Public Hearing: Paradise Park Site Plan

Paradise Park Site Plan: Type III

(2024-019-CUP) PSR/SUB/SEPA/LLD/VAR/CAR/TRE/GEO

October 18, 2024

Figure 3 – Proposed Preliminary Site Plan/Plat

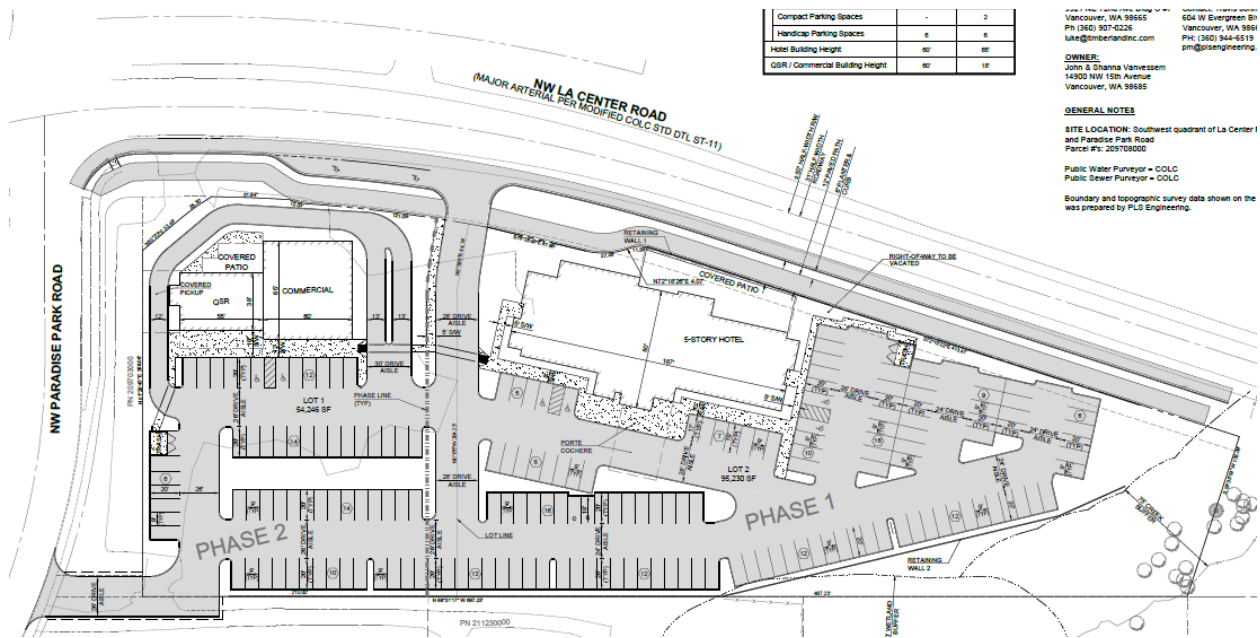
As a condition of approval, the plat must clearly show the required building line (RBL) and note that the parking setback line shall be a minimum of 30 feet from the designated (RBL).

As a condition of approval, the applicant is required to clearly show the required building envelope on the short plat and site plan.

Figure 2: Mapped Stream and Riparian Buffer and Category IV Wetland

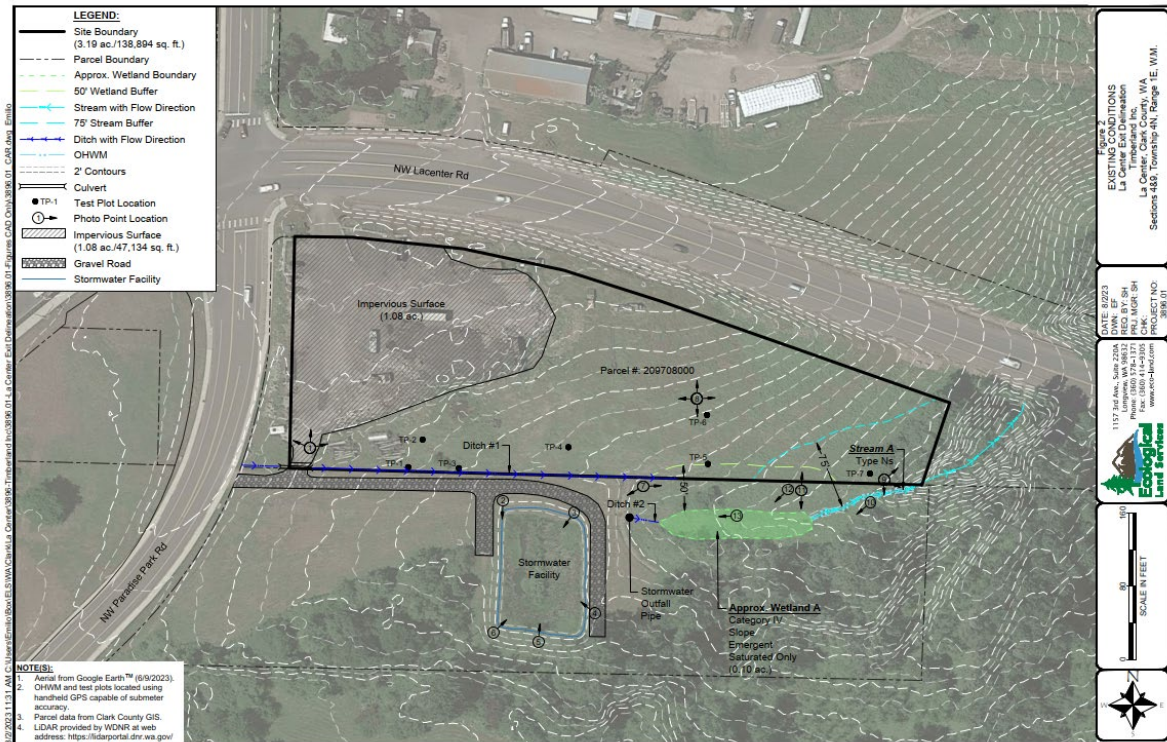
Findings: According to Clark County Maps Online and the submitted Critical Areas Report, the eastern portion of the site is within a riparian habitat buffer. The submitted critical areas report verified an unnamed non-fish-bearing (Type Ns) stream – see Figure 2. A Type Ns stream requires a 75-foot riparian buffer in accordance with Table 18.300.090(2)(f). The applicant is not proposing any temporary or permanent impacts within the riparian buffer.

Pursuant to LCMC 18.300.090(2)(g)(ii), the edge of the buffer area shall be clearly staked, flagged, and fenced prior to and through construction completion. The buffer boundary markers shall be clearly visible, durable, and permanently affixed to the ground. As a **condition of approval**, the applicant shall stake, flag, and fence the riparian area buffer prior to any site improvements prior to and through the duration of site construction.

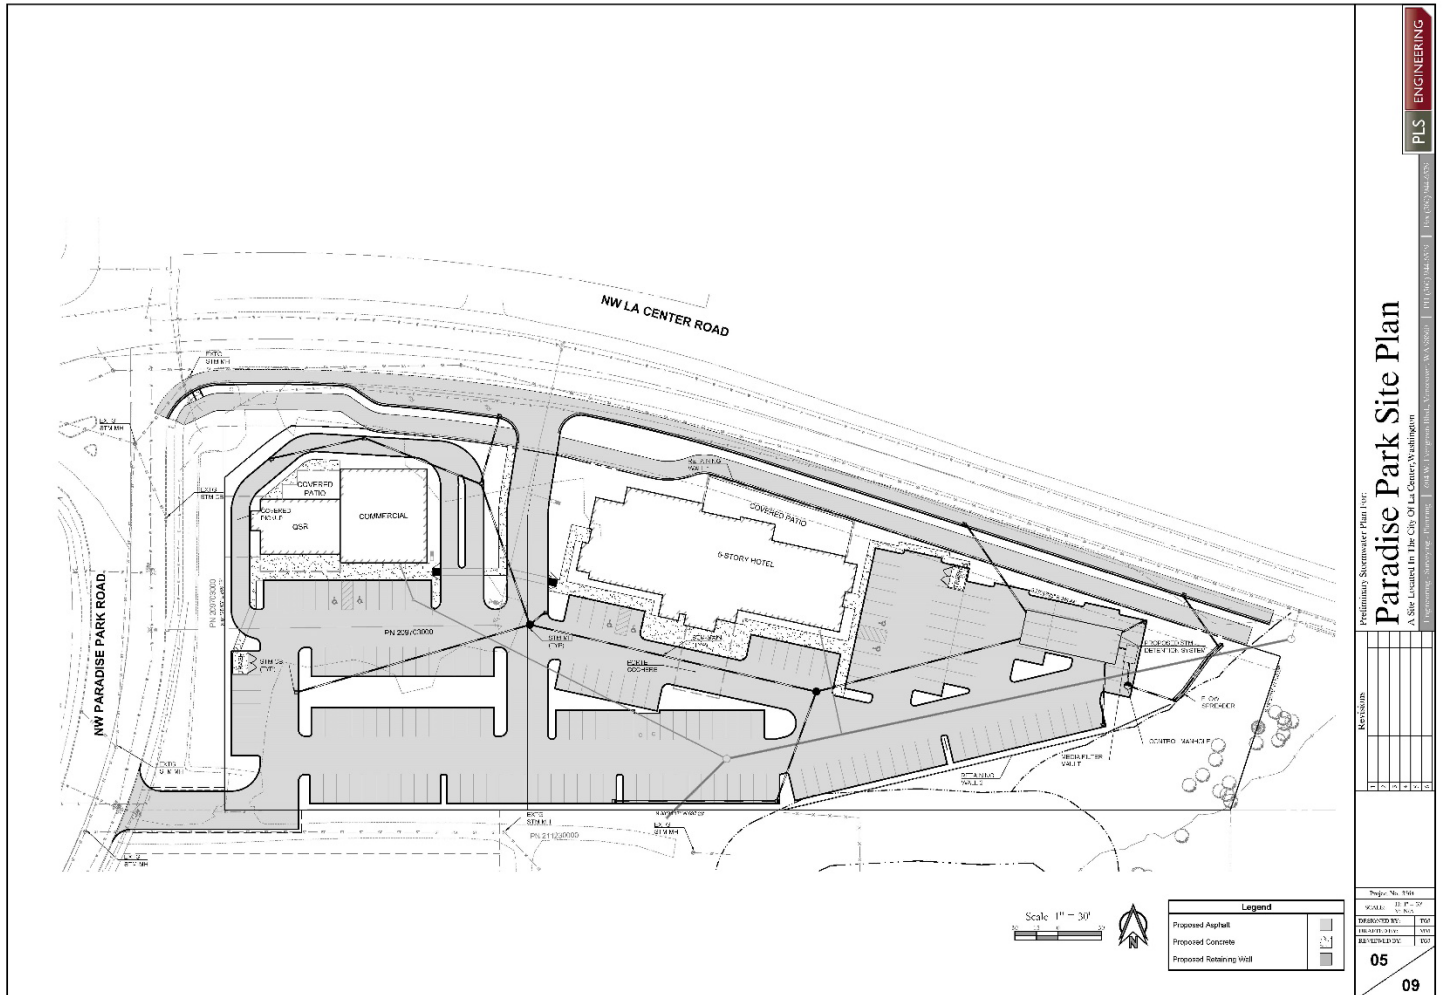
Based on subgrade analysis, the report recommends, a site pavement section of 3" asphalt over 10 inches of aggregate base. It also recommends adding 0.5 inches of asphalt and 2" of aggregate base, for a total depth of 3.5-inches of asphalt over 12-inches of aggregate base.

Since La Center Road is classified as a Major Arterial, the minimum depth of asphalt is 0.55-feet, or 6.6-inches of asphalt. The report does not indicate the AASHTO soil classification, which is what is used by the city road classification to determine how much aggregate base to use. Based on the USDA soil map the soil at the location of the half street improvements, the AASHTO rating is A-4 for Gee silt loam. The minimum asphalt depth is 0.6-foot depth over 12-inch depth of aggregate base. **The city will require in public right of way that a minimum depth of 0.6-feet or 7.2-inches of asphalt over 12-inches of aggregate base be used.**

Retaining Walls shall be designed per the recommended parameters in the Geotechnical Report. Grading for retaining walls can be shown on the Engineering plans, but the applicant will need to obtain a building permit for any retaining wall design.
